# City of Ryde Submission

**For Modification 5 of SSD-5093  
6 Halifax Street, Macquarie Park  
(Lot 117, DP 1224238)**

**Submission Date: 31 August 2022**

Figure1. Proposed changes regarding land zoning in Housekeeping Review Planning Proposal 2022

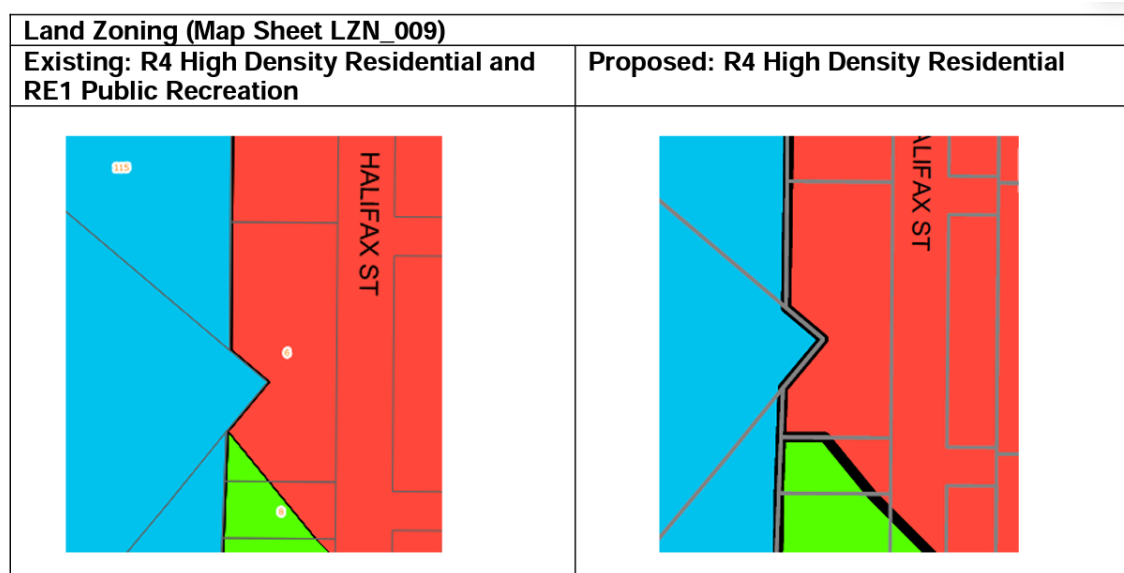
The Planning Proposal includes the rezoning of a small portion of land zoned 'RE1 Public Recreation' to 'R4 Low Density Residential' on the subject site to correct a zoning anomaly. It also seeks to apply a floor space ratio (FSR) of 3:1 and maximum height of 75 meters across the whole site to be consistent with the remainder of the site (refer to Figures 1, 2 & 3 below).

The assumptions used for FSR calculation in Table 2 of the submitted Statement of Environmental Effects (SEE) are inconsistent with the above exhibited Planning Proposal. Based on the FSR sought by the Planning Proposal, the site will only achieve a base GFA of 7,521m<sup>2</sup>, or a maximum GFA of 9,025m<sup>2</sup> should a bonus of 20% is applied under the *State Environmental Planning Policy (Housing) 2021* (Housing SEPP).

Council staff consider that any increase in the GFA on the site should not exceed the maximum permitted GFA under the RLEP 2014 to maintain an appropriate density relationship with existing and future developments in Lachlan's Line. Therefore, subject to 100% of the GFA being used for affordable housing, it is recommended that the amended GFA on Lot 117 for this SSD modification is to be capped at 9,025m<sup>2</sup>. Should any additional GFA be sought on the site, it can be considered at the future Development Application (DA) stage provided that the Applicant is able to demonstrate sufficient design merits through Clause 4.6.

Figure 4. Subject site's relative location to the Wicks Road South (Garungul) neighbourhood

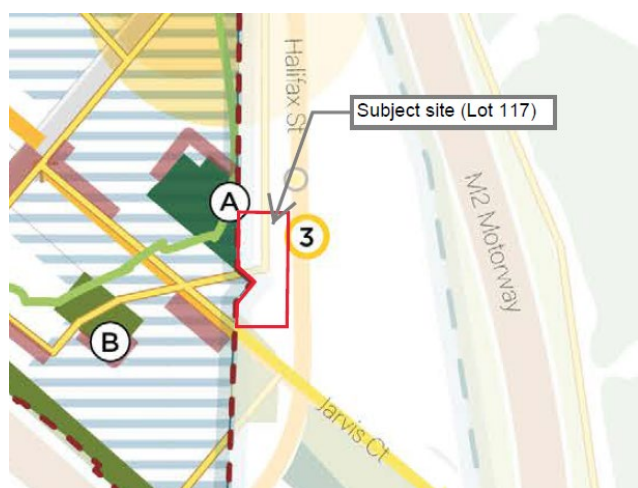
The proposed modification should take into consideration the increased overshadowing impact on the proposed future 'Corridor Square' (labelled 'A' in Figure 4) located immediately to the west of the site and also its implications on a fine-grained pathway (represented by a yellow line in Figure 4) appeared running through the northern portion of the site.
